# HISTORIC AND DESIGN REVIEW COMMISSION

**HDRC CASE NO:** 2020-067  
**COMMON NAME:** 100 LABOR  
**ADDRESS:** 600 E CESAR E CHAVEZ BLVD  
**LEGAL DESCRIPTION:** NCB 708 BLK 8 LOT 29  
NCB 709 BLK 4 LOT 1 - 11, P-100 (0.455 AC); NCB 1024 BLK LOT NW  
IRR PT OF BLK  
**ZONING:** IDZ-3, H  
**CITY COUNCIL DIST.:** 1  
**DISTRICT:** Lavaca Historic District  
**APPLICANT:** George Torres/Alamo Architects  
**OWNER:** Lucila Diaz/San Antonio Housing Authority  
**TYPE OF WORK:** Amendments to a previously approved design for new construction  
**APPLICATION RECEIVED:** January 31, 2020  
**60-DAY REVIEW:** March 31, 2020  
**REQUEST:**

The applicant is requesting a Certificate of Appropriateness for approval to amend a previously approved design for new construction. Within this amendment, the applicant has proposed the following:

OVERVIEW OF DESIGN CHANGES - AERIAL FROM CESAR E. CHAVEZ BLVD.

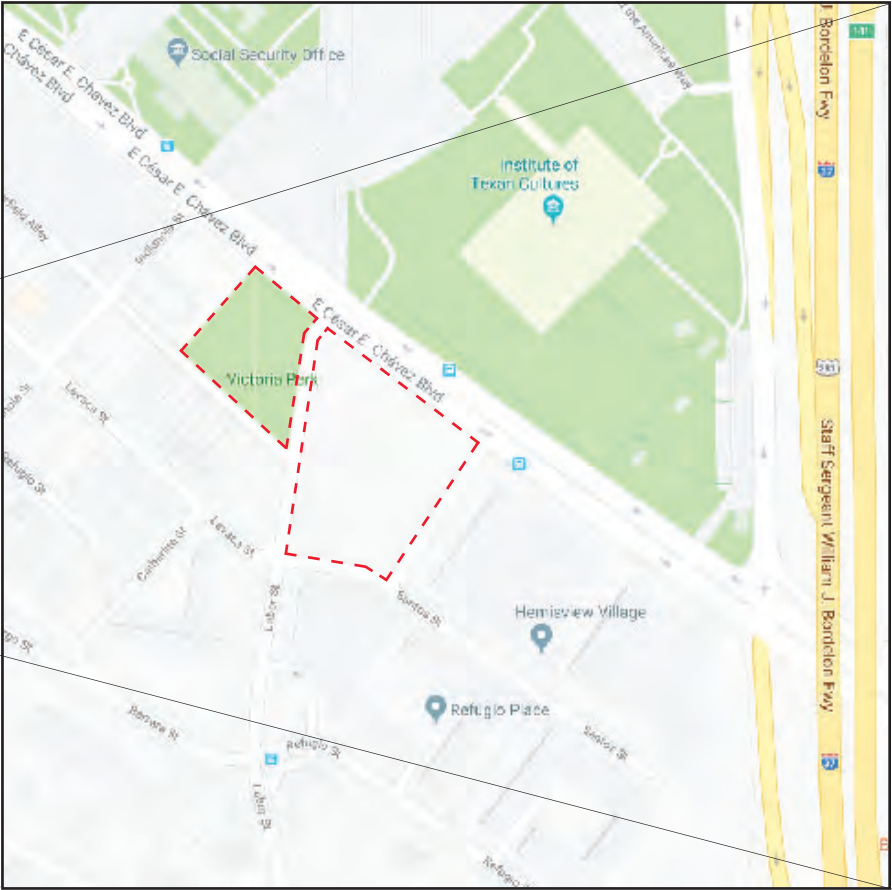
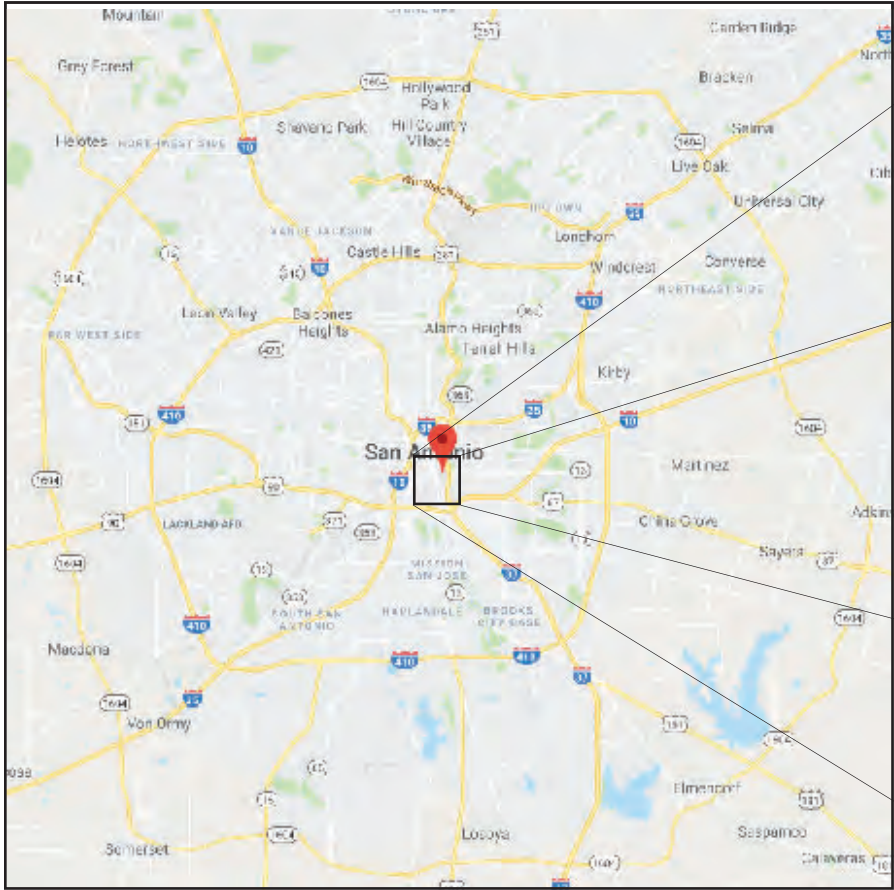
- c. **HEIGHT REDUCTION** – The applicant has proposed to reduce the overall height of buildings 1 and 4 from 5-stories to 4-stories. Staff finds the proposed reduction in height to be appropriate.

- d. **BRICK CLADDING** – The applicant has proposed to reduce the previously approved amount of brick to only the Cesar E Chavez and Labor Street elevations. Previously, brick was proposed on other elevations, including those that are interior to the site, in addition to lap siding and stucco. The applicant has proposed lap siding and stucco exclusively at those locations now. The applicant has noted lap siding with an exposure of six (6) inches. Generally, staff finds the proposed modifications to be appropriate; however, staff finds that the proposed lap siding should feature a smooth finish.

- f. **STRUCTURED PARKING** – The applicant has proposed to increase the overall height of structured parking from 4 to 5 stories. Staff finds the proposed structured parking to be appropriate as it will primarily be screened from view at the right of way; however, staff finds that additional consideration to given the cladding of the parking structure. Currently, the structure has been proposed to feature to exposed precast panels.

- i. That the applicant incorporate screening elements into the design of the proposed parking structure's exposed precast panels. Visual separation should be created on this façade.
- ii. That all windows feature a recess within walls.
- iii. That the proposed surface parking on Garfield feature both buffering and screening elements including fencing and landscaping materials.
- iv. **ARCHAEOLOGY** – The project shall comply with all federal, state, and local laws, rules, and regulations regarding archaeology, as applicable.

MATERIALS

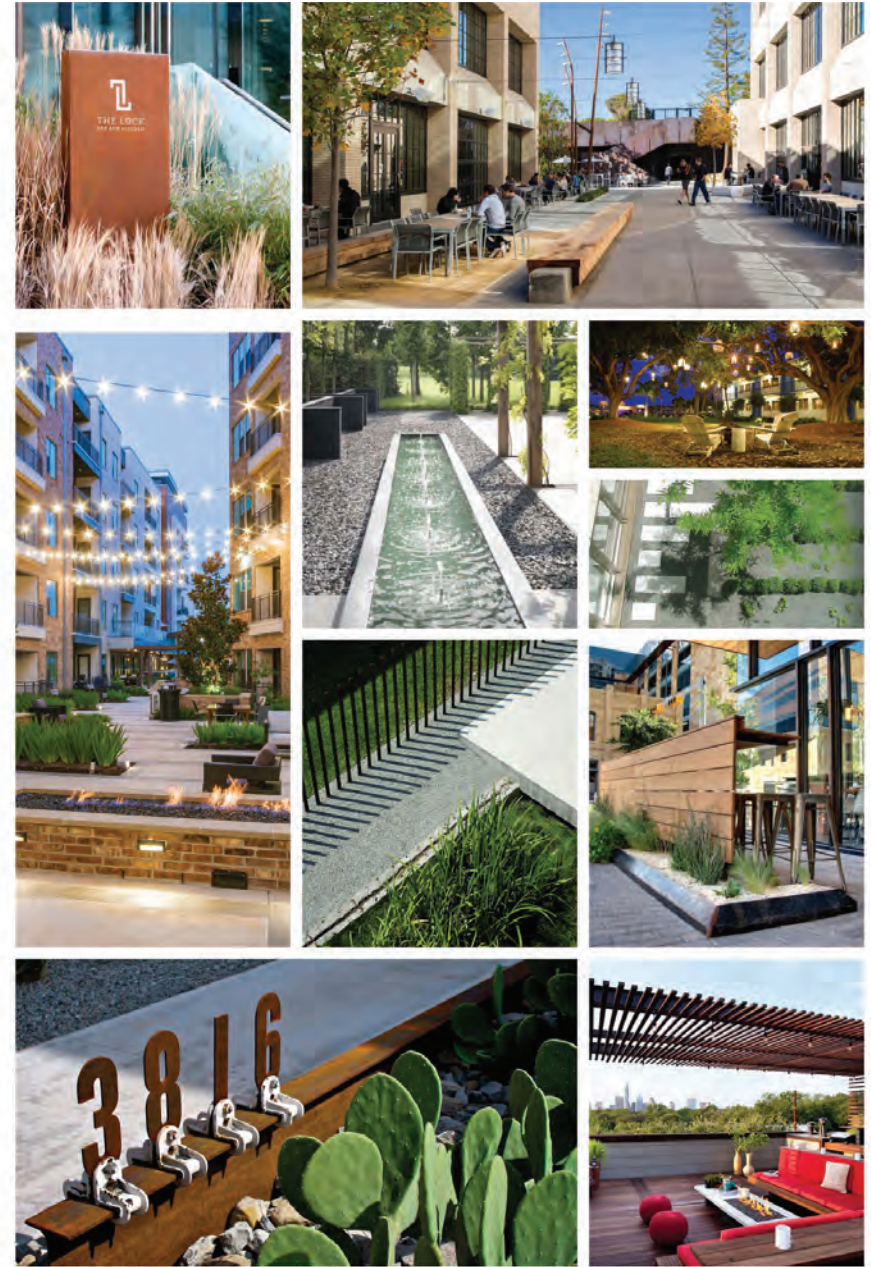
- g. **WINDOWS** – The applicant has proposed to install aluminum windows, doors, and storefront systems to feature a dark bronze color. Staff finds the proposed windows to be appropriate; however, staff finds that all windows should feature a recess in their installation.
